# UNITED STATES PATENT AND TRADEMARK OFFICE

APPLICATION NO.	FILING DATE	FIRST NAMED INVENTOR	ATTORNEY DOCKET NO.	CONFIRMATION NO.
10/752,700	01/08/2004	Kazuyuki Kuwada	Q79277	5921
65565 7590 03/27/2008 SUGHRUE-265550 2100 PENNSYLVANIA AVE. NW WASHINGTON, DC 20037-3213				
EXAMINER				
SUCH, MATTHEW W				
ART UNIT		PAPER NUMBER		
2891				
MAIL DATE		DELIVERY MODE		
03/27/2008		PAPER

### Office Action Summary

## **DETAILED ACTION**

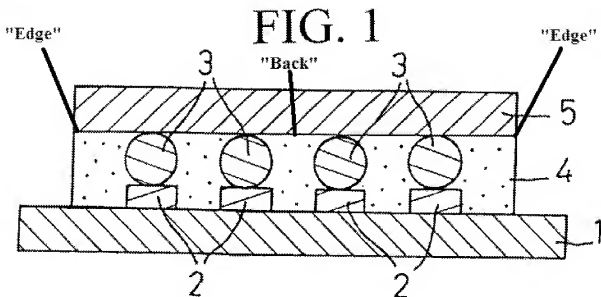
24. Regarding the rejection of claims 1-2 under 35 U.S.C. 102(b) as anticipated by Hotta ('096): The Applicant argues that the prior art reference of Hotta does not anticipate the claims because "there is no description about encapsulation with a sheet having tackiness". This is not persuasive for at least the following reasons. Firstly, the claim does not distinguish what structural features of the recitation of "sheet" to distinguish the claim from the prior art of Hotta. Since the element of Hotta is a long and thin feature, it must be a "sheet". Hotta even refers to the element as a "sheet" (see Col. 5, Lines 65-66, for example). Furthermore, the material of Hotta has "high adhesion" and therefore must have some level of tackiness since tackiness is merely a measure of adhesiveness.

25. Regarding the rejection of claims 1-2 under 35 U.S.C. 102(b) as anticipated by Misumi ('484): The Applicant argues that Misumi does not anticipate the claims because the semiconductor element is not "encapsulated". However, this is not persuasive for at least the following reasons. The manner in which the claim is written does not limit exactly how the semiconductor element is "encapsulated" to distinguish from the prior art of Misumi. For example, Misumi shows the semiconductor element is "encapsulated" across the entire back surface and edges of the semiconductor element (see attached Figure for example).
